Item Name: Crosstube Turning Detail

DART AEROSPACE LTD		Work Order:	85828
Description: Crosstube Assembly (205/212/412 High Fwd)		Part Number:	D212-664-141
Inspection Dwg: D212-664-141 Rev: D		Page 1 of 2

DRAWING NO. D212-664-141	TITLE XTUBE ASSY (205/212/412 HI FWD)	REV. D	DART AEROSPACE LTD ENGINEERING ORDER		D.E.O. NO. D212-664-141-D-1	SHEET NO. SHEET 1 OF 2	SCALE NTS
DRAWN	CHECKED	MFG. APPR.	APPROVED	DE APPR.			
DATE 11.04.07	DATE 11.04.11	DATE 11.04.12	DATE 11/04/12	DATE 11.04.12

DRAWING NO. D212-664-141	TITLE CROSSTUBE ASS'Y (205 HI FWD)	REV. D	DART AEROSPACE LTD ENGINEERING ORDER		D.E.O. NO. D212-664-141-D-2	SHEET NO. SHEET 1 OF 1	SCALE NTS
DRAWN <i>UP</i>	CHECKED <i>ASS</i>	MFG. APPR. <i>AB</i>	APPROVED <i>MP</i>		DE APPR. <i>HT</i>		
DATE 11.07.15	DATE 11.07.20	DATE 11.07.21	DATE 11/07/21		DATE 11.07.21

**D212-664-141/-141B
ASSEMBLY DETAIL**

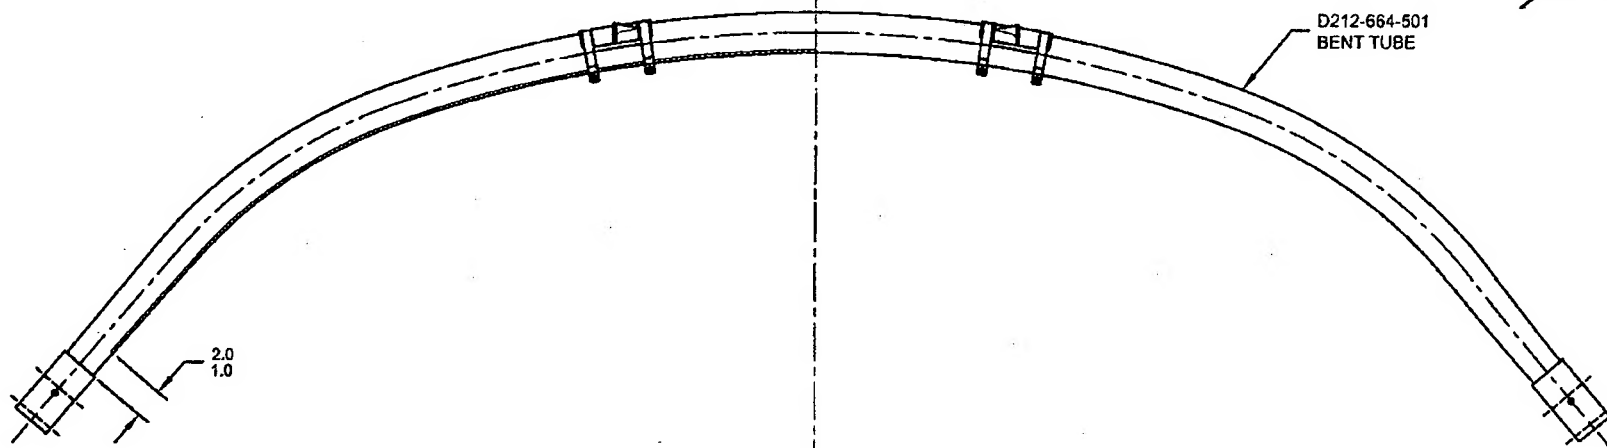
ADD AN INSPECTION WINDOW TO UNDERSIDE OF CROSSTUBE.

NOTES 2 OF SHEET 1 IS AMENDED AS FOLLOWS:

- 2) FINISH: CHEMICAL CONVERSION COAT PER DART QSI 005 4.1
PRIME INSIDE AND OUTSIDE PER DART QSI 005 4.2
PAINT OUTSIDE PER DART QSI 005 4.2

- 2) FINISH: CHEMICAL CONVERSION COAT PER DART QSI 005 4.1
PRIME INSIDE AND OUTSIDE PER DART QSI 005 4.2
MASK UNDERSIDE OF CROSSTUBE AS SHOWN (HATCHED AREA) AND
PAINT OUTSIDE PER DART QSI 005 4.2
REMOVE MASKING AND APPLY CLEAR COAT

MASK AREA PRIOR TO PAINTING,
REMOVE MASKING AFTER PAINT
AND APPLY CLEAR COAT
